SITE ADDRESS ANCOATS CONCENIENCE STORE 126 OLDHAM ROAD, ANCOATS, M4 6AG			TITLE PROPOSED AUTOMATED TELLER MACHINE (ATM) INSTALLATION FOR CASHZONE			drawing approval		
DRAWN MAL			DATE 16/01/23			NAME:-		
REF/DRG No. E025850			SCALE VARIOUS @A3			POSITION:-		
SHEET			REVISION 01			APPROVED:-		
REVISION			DESCRIPTION			SIGNED:-		
04						DATE		
03						BY		
02								
01			PLANNING AMENDMENT - DESIGN CHANGE TO GLAZING LAMI SPLIT. NOTES UPDATED			12/08/25		
						CT

PROPOSED ELEVATION

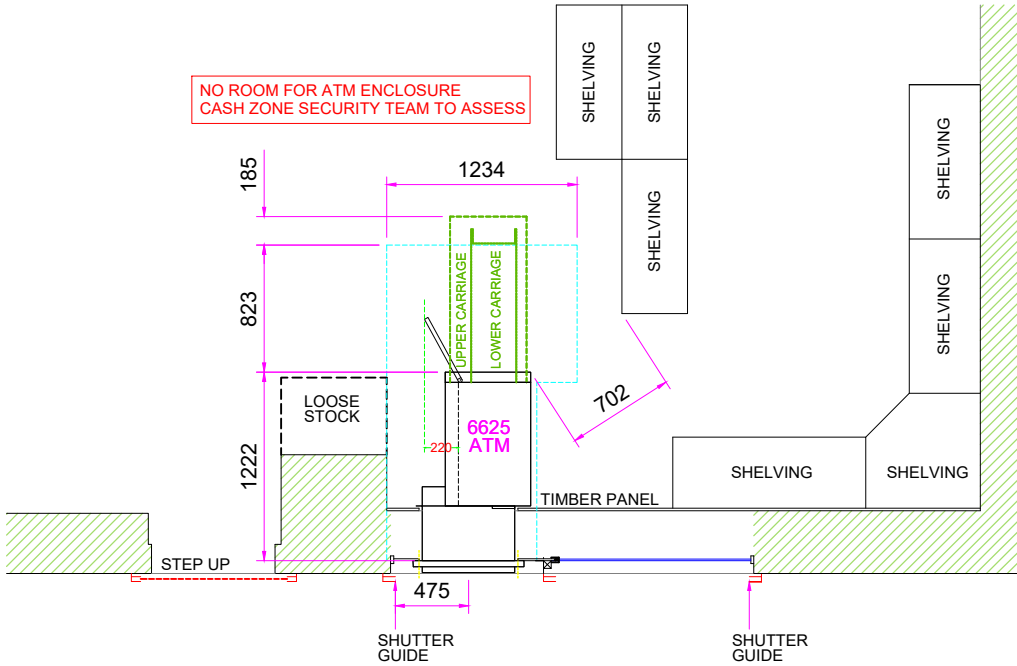
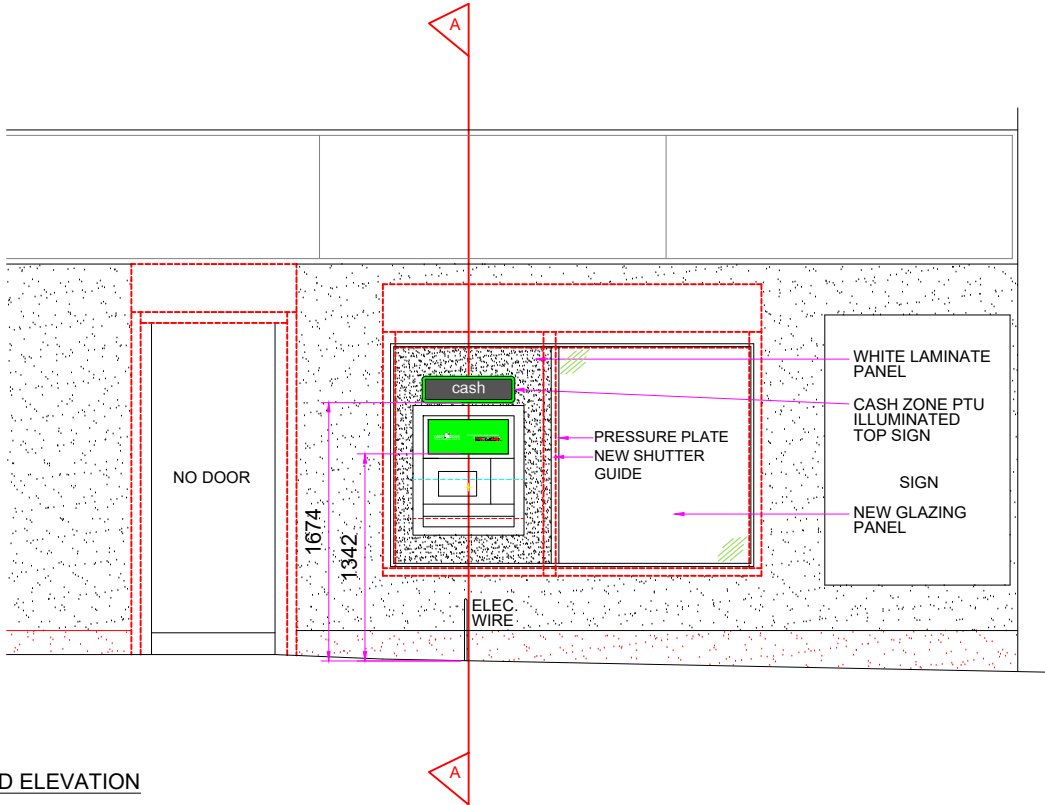
REV01- DISCONNECT AND REMOVE EXISTING ATM, SIGNAGE AND LAMINATE PANEL.
INSTALL NEW PRESURE PLATE, SMALLER GLAZING PANEL AND WHITE LAMINATE PANEL WITH APERTURE FOR ATM FACE. REFIT THE ATM, SIGNAGE AND RECONNECT TO THE ELECTRICS.
UNISOLATE AND CUT DOWN THE EXISTING ROLLER SHUTTER AND FIT NEW GUIDE RAIL AND INFILL SECTION
